Review – Adding Capacity at Heathrow Airport

Job Number	J713
-------------------	------

Issue No.	Report No.	Date	Status	Reviewed by
1	713/1/D1	15.02.08	Final Report	Prof.Duncan Laxen
2				
3

Measured annual mean nitrogen dioxide concentrations (blue line) and predicted annual mean nitrogen dioxide concentrations (pink line) at LHR2 ($\mu\text{g}/\text{m}^3$)

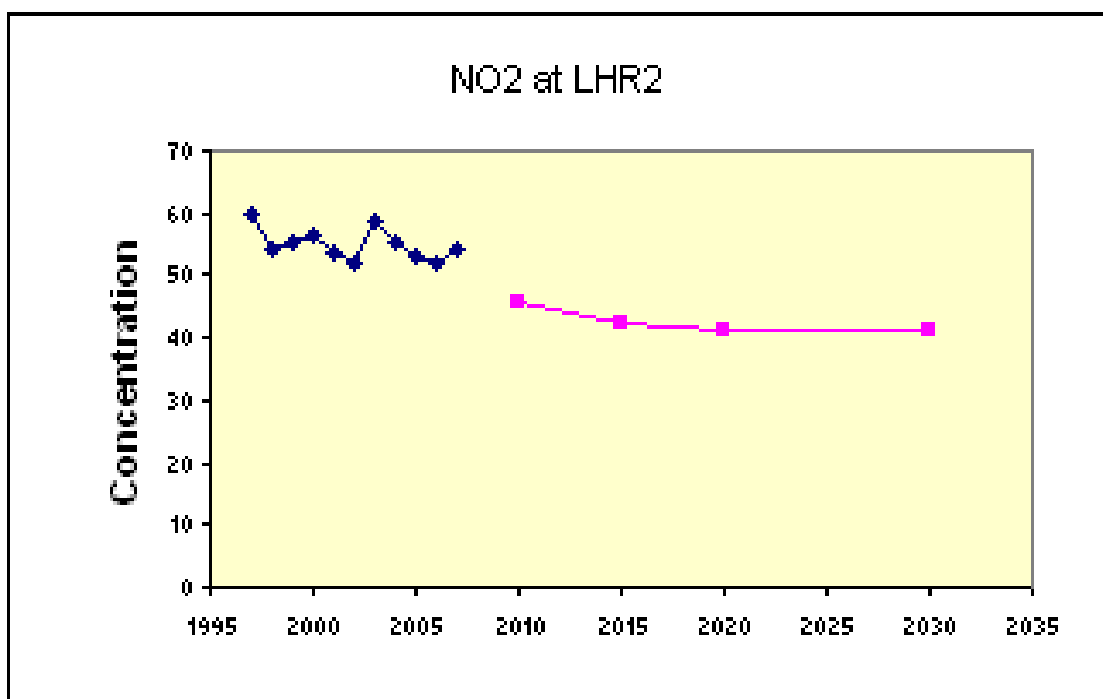
- 1.14 It is also useful to compare trends in measured concentrations with future year concentrations predicted by the model. As an example, the figure below shows the measured annual mean nitrogen dioxide concentrations at the LHR2 site, located just to the north of the northern runway, for the period 1996 to 2007². The figure also shows the predicted annual mean nitrogen dioxide concentrations for 2010, 2015, 2020 and 2030³.
- 1.15 The measured nitrogen dioxide concentrations show no strong evidence of a decline over the 11 year period. Indeed, the concentration in 2007 is the same as in 1997. To achieve the predicted concentrations in 2010 and beyond would thus require a substantial “step change” that appears wholly inconsistent with the empirical evidence to date. This disparity is not addressed within the various technical reports.

Figure 1: Plotted values from Table 2. Dotted line is 1:1. Solid line is best fit.

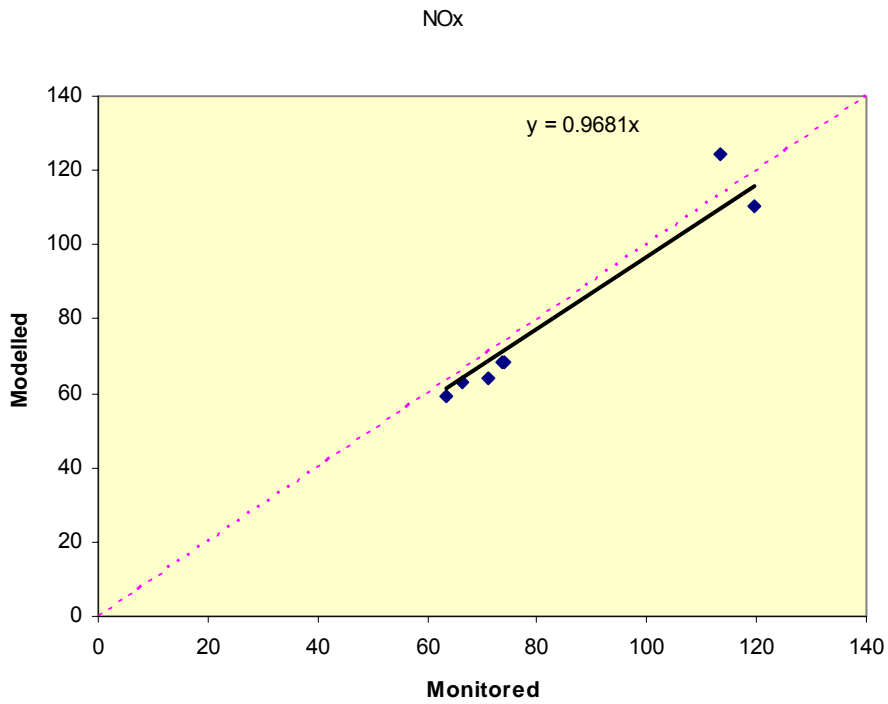
- 4.29 Model verification procedures are discussed in detail within Annex 3 of the Technical Guidance Note LAQM.TG(03) which has been published by Defra. If the approach recommended in this guidance is followed, the slopes of the regression lines in Figures 1 and 2 suggest that the model is under-predicting NO_x by 3.3%, and NO₂ by 4.4%.

Figure 2: Plotted values from Table 3. Dotted line is 1:1. Solid line is best fit.

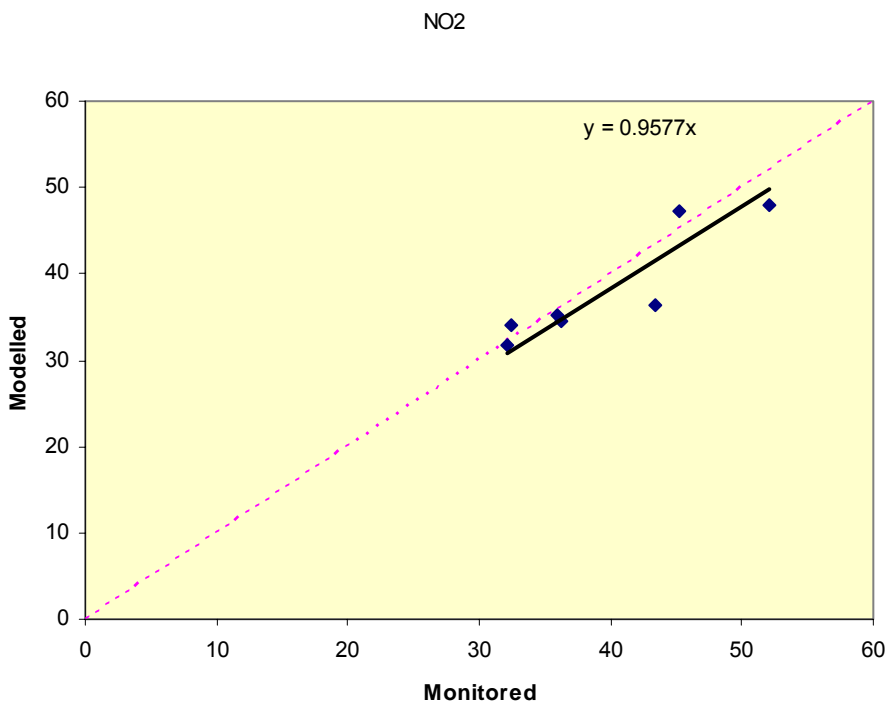
- 4.30 The outcome of this analysis is that there is potential that exceedences of the limit value (40 µg/m³) could realistically occur **where predicted annual mean concentrations of nitrogen dioxide exceed about 38 µg/m³.**

Figure 3: Measured annual mean nitrogen dioxide concentrations (blue line) and predicted annual mean nitrogen dioxide concentrations (pink line) at LHR2 ($\mu\text{g}/\text{m}^3$)

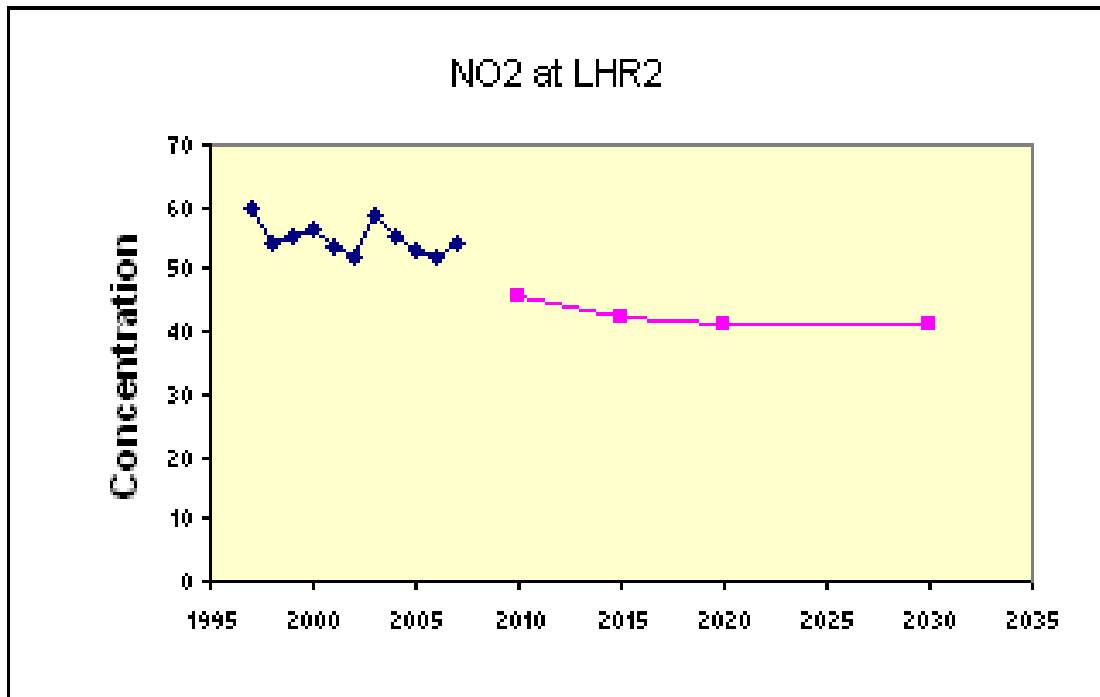
4.39 To take this analysis further, Figure 3.4 from the Atkins report has been reproduced, and is shown in Figure 3 below. In this case it was possible to obtain a full 12 months data for 2007, although some provisional data are included. The predicted annual mean nitrogen dioxide concentrations for 2010, 2015, 2020 and 2030 have been derived from the CERC report⁶.

4.40 It is evident that the measured nitrogen dioxide concentrations show no strong evidence of a decline over the 11 year period from 1996 to 2007. Indeed, the concentration in 2007 is the same as in 1997. To achieve the predicted concentrations in 2010 and beyond would thus require a substantial “step change” that appears wholly inconsistent with the empirical evidence to date. This disparity is not addressed at all within the Atkins report. It is though consistent with the under-prediction of the model discussed above.
